## KERN COUNTY WASTE MANAGEMENT DEPARTMENT

**RE: China Grade Sanitary Landfill; Kern County  
Comments on Tentative Waste Discharge Requirements**

Thank you for providing Kern County Waste Management Department (KCWMD) the opportunity to provide comments on the Tentative Waste Discharge Requirements (WDRs) dated October 2, 2012, for the China Grade Sanitary Landfill.

China Grade Sanitary Landfill  
 Historical Data  
 bis(2-Ethylhexyl)phthalate (ug/L)

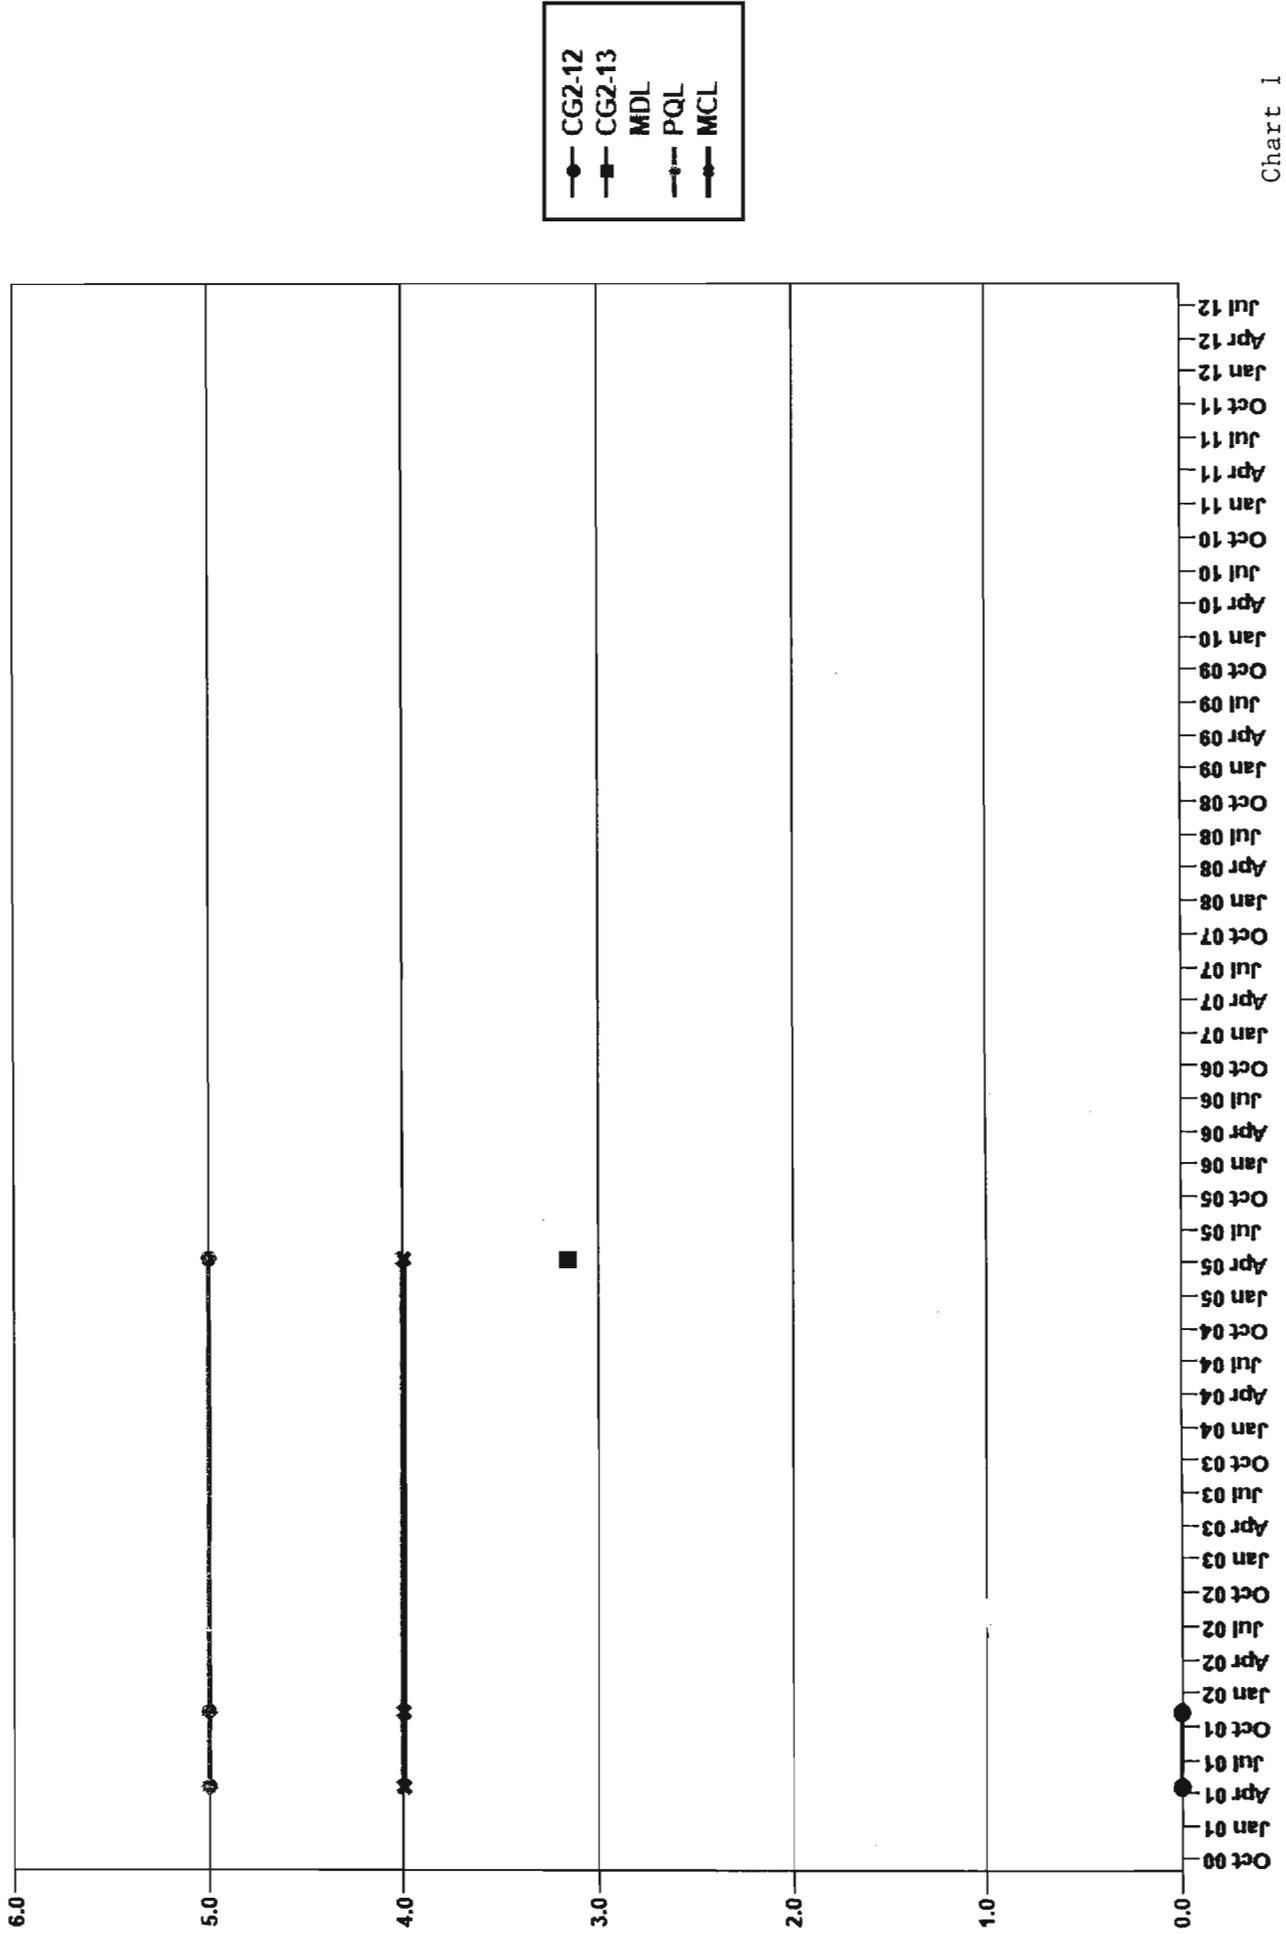
Of the six VOCs detected at the China Grade SLF since 2000, three (bis-2-ethylhexyl phthalate, diethyl phthalate, and PCE) have only been detected once in the past 12 years. All have been at trace levels with no detections since 2006 (Charts 1-3). Detections of Trichlorofluoromethane have occurred in two wells over the past 12 years. All have been at trace levels with no detections since 2007 (Chart 4). Detections of Acetone, a standard laboratory cleaning solvent, are suspect due to the fact that they have occurred only once in three different wells over the past 12 years (Chart 5).

China Grade Sanitary Landfill  
 Historical Data  
 Dichlorodifluoromethane (ug/L)

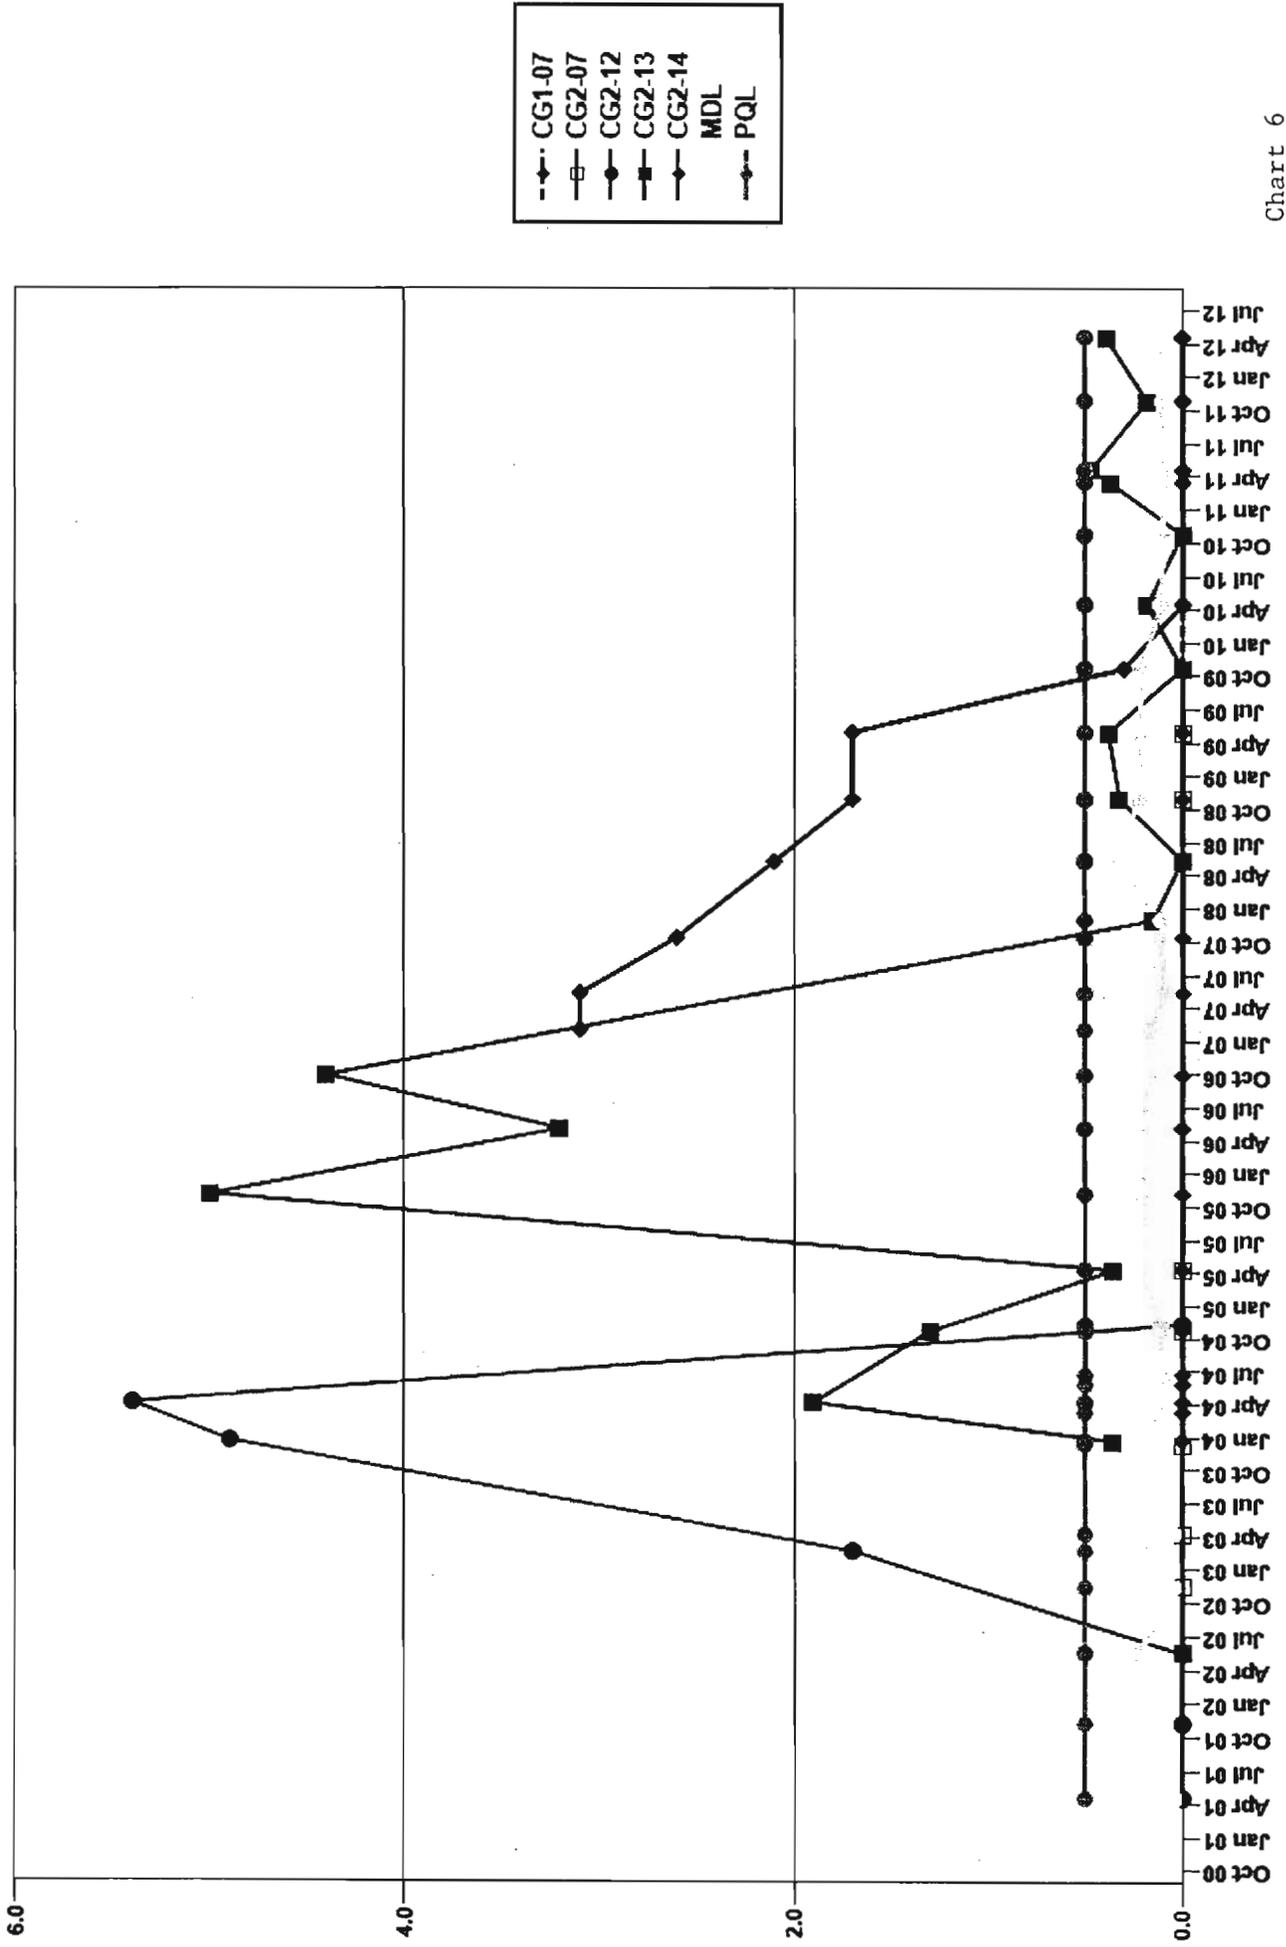
The only regularly VOC detected over the past 12 years at the China Grade SLF has been dichlorodifluoromethane (Freon 12). There is no Maximum Contamination Limit (MCL) in either federal or state drinking water standards for Freon 12. The chronic (lifetime) health advisory limit is 1,000 µg/L. The maximum concentration of Freon 12 detected in any well at the landfill was 5.4 µg/L in well CG2-12 in 2004. Chart 6 illustrates the detections of Freon 12 over the past 12 years in wells CG2-12, CG2-13, and CG2-14. Freon 12 was last detected in well CG2-12 in 2004. The last detection in well CG2-14 was in 2009. Freon 12 detections in well CG2-13 have been at trace levels since 2009.

CHINA GRADE SANITARY LANDFILL  
 LFG PERIMETER MONITORING WELLS

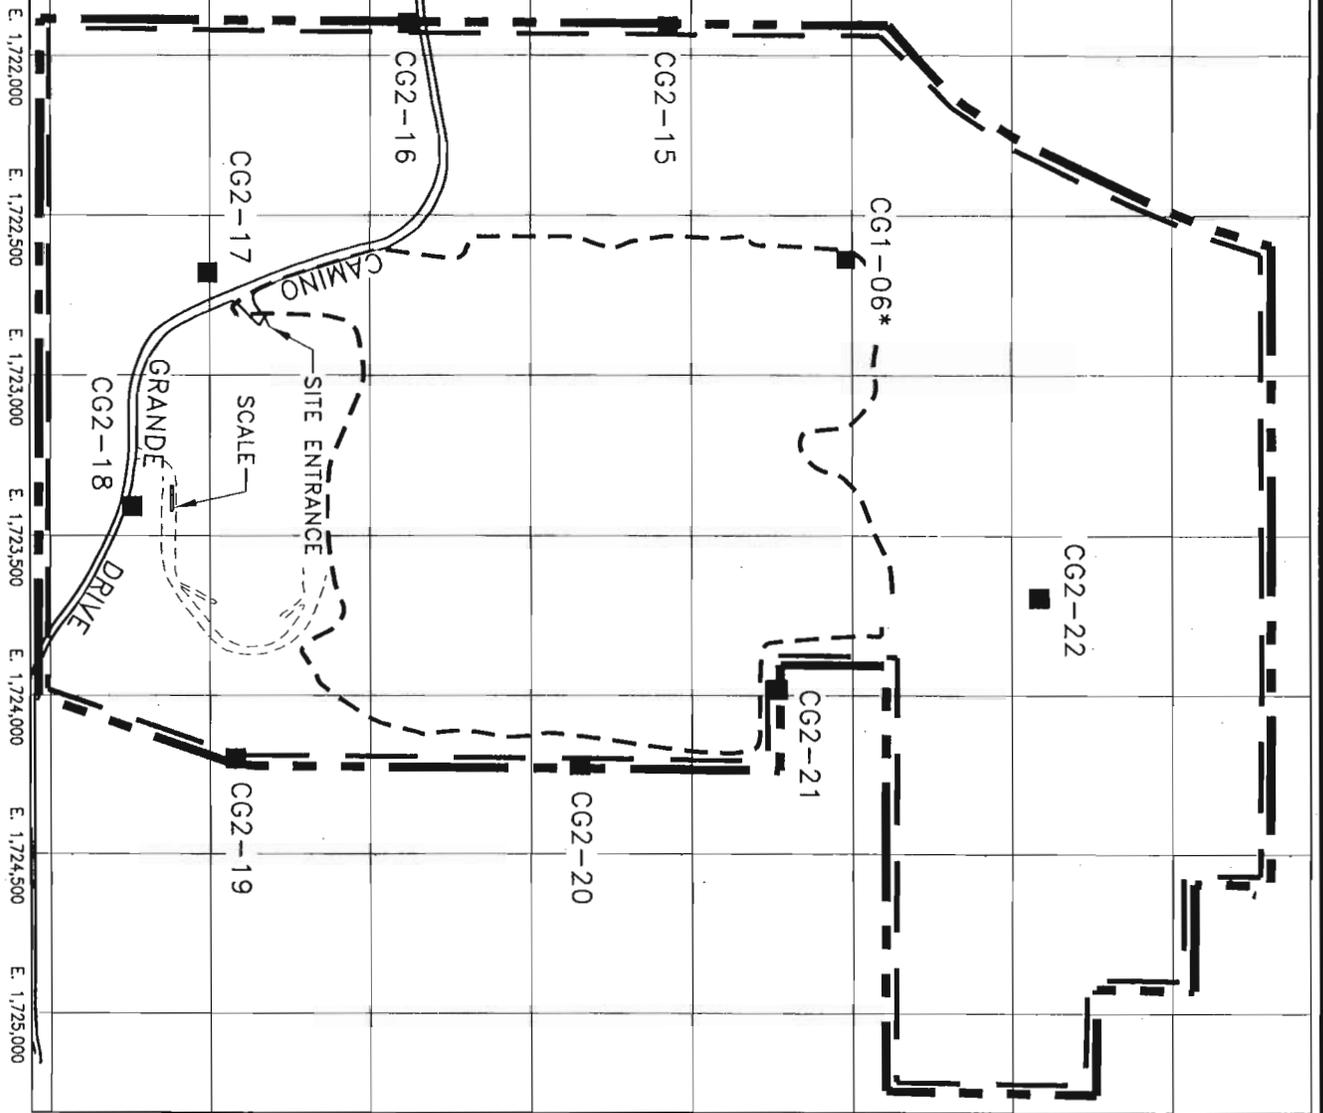
Attachment B is missing three of the eight existing landfill gas (LFG) perimeter monitoring wells and the facility boundary is incorrect (see attached figures).

Comment: Attachment B (Site Map) is missing landfill gas perimeter monitoring points CG2-15, -16, and -19. In addition, the facility boundary is incorrect on both Attachment A (Location Map) and Attachment B.
